# TOWN OF PALM BEACH

## TOWN COUNCIL MEETING

WEDNESDAY, FEBRUARY 13, 2013

- A. Appeals  
**TIME CERTAIN: NOT BEFORE 11:00 A.M**
1. Appeals of Landmarks Preservation Commission's Decision Regarding COA#023-2012 (Del Frisco Restaurant) by William Cooley, Palm Beach Towers, and Lory Volk.  
[John Page, Director of Planning, Zoning and Building] Page 79
2. Appeal of Landmarks Preservation Commission's Decision Regarding COA#004-2013 (Brown Harris Stevens) by Palm Beach Towers. [John Page, Director of Planning, Zoning and Building] Page 179
- B. Time Extensions & Waivers
1. Request for Waiver of Section 42-199, Hours of Construction Work, at 401 Worth Avenue Per Letter Dated January 16, 2013, from Donald B. Scott, Jr. Page 224

Existing Southeast View

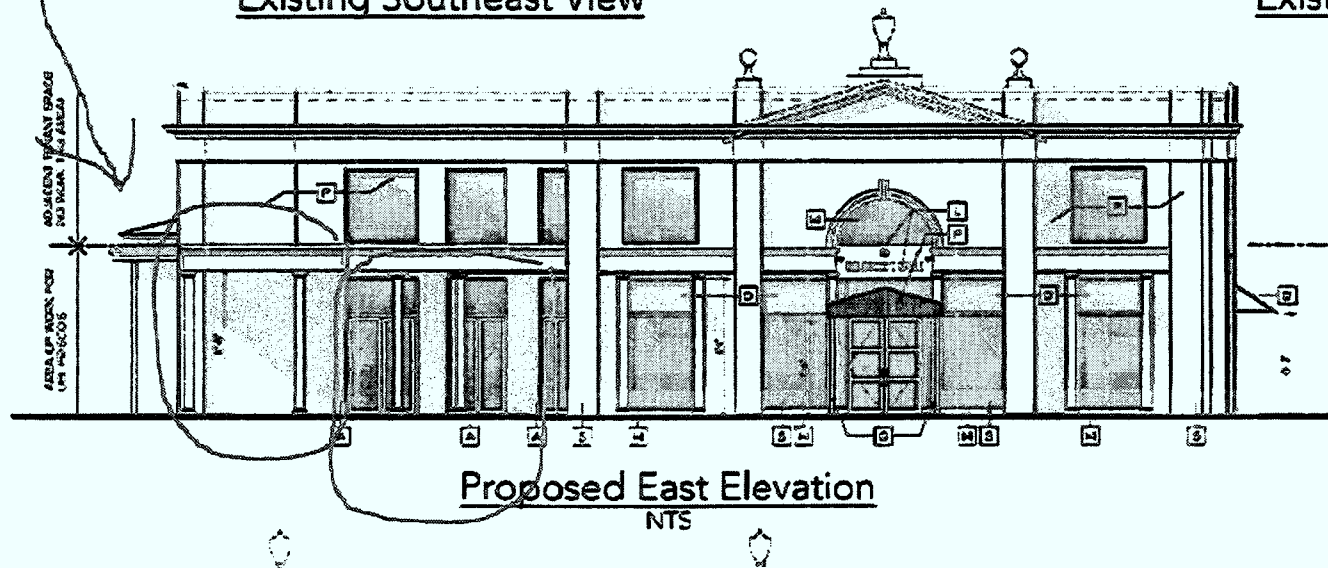
**The proportions and perspective- entirely inaccurate - and no drawing of the curvilinear feature is included.**
